Access Compliance Report

Public Rights-of-Way

Intersection ID: 15263	Main Street: FOSTER_AV	Cross Street: S_TRYON_ST	Location: SW
ADA ID: 336FE7BC6273	Ramp Type: PerpDiag	Initial Pass/Fail: Fail	Overall Compliance: No
			Severity Score: 33.75

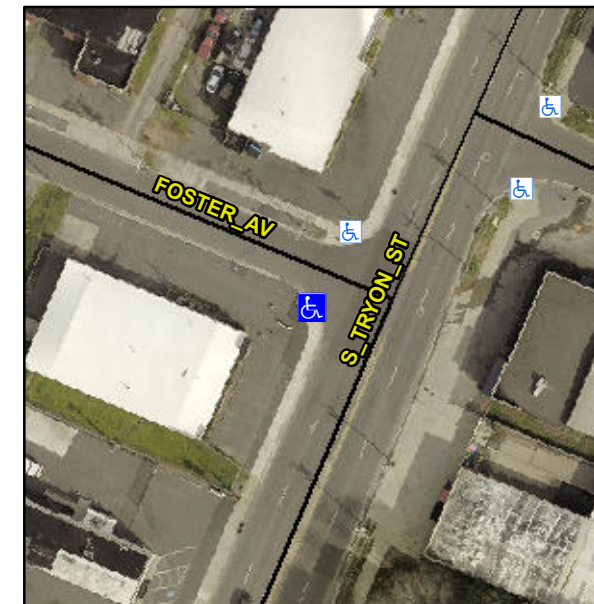
Not Found, R304.5.1, R304.5.3

Compliance	Description	Data	Compliance	Description	Data
N/A	Ramp Length (in)	67.0	Yes	Ramp Slope (%)	5.4
No	Ramp Width (in)	47.5	No	Ramp XSlope (%)	7.3
N/A	Flare Type LT	N/A	N/A	Flare Type RT	N/A
N/A	Flare Slope LT (%)	N/A	N/A	Flare Slope RT (%)	N/A
N/A	Flare Traversable LT?	N/A	N/A	Flare Traversable RT?	N/A
N/A	Landing Length (in)	N/A	N/A	DWS Provided?	N/A
N/A	Landing Width (in)	N/A	N/A	DWS Contrast?	N/A
N/A	Landing Slope (%)	N/A	N/A	DWS Length (in)	N/A
N/A	Landing X Slope (%)	N/A	N/A	DWS Full Width?	N/A
N/A	Landing Curb? (Y/N)	N/A	N/A	DWS Offset (in)	N/A
N/A	Shared Landing?	N/A			
N/A	Gutter Ponding?	N/A	N/A	Gutter Slope (%)	N/A
N/A	Gutter Lip Ht (in)	N/A	N/A	Gutter X Slope (%)	N/A
N/A	Painted X Walk1?	No	N/A	Painted X Walk2?	No
	X Walk 1 Direction	To E		X Walk 2 Direction	To NE
N/A	X Walk 1 Width (in)	N/A	N/A	X Walk 2 Width (in)	N/A
	X Walk 1 Slope (%)	2.4		X Walk 2 Slope (%)	2.1
	X Walk 1 X Slope (%)	2.2		X Walk 2 X Slope (%)	2.9

Remove & Replace Curb Ramp With Two New Directional Ramps or Equivalent.
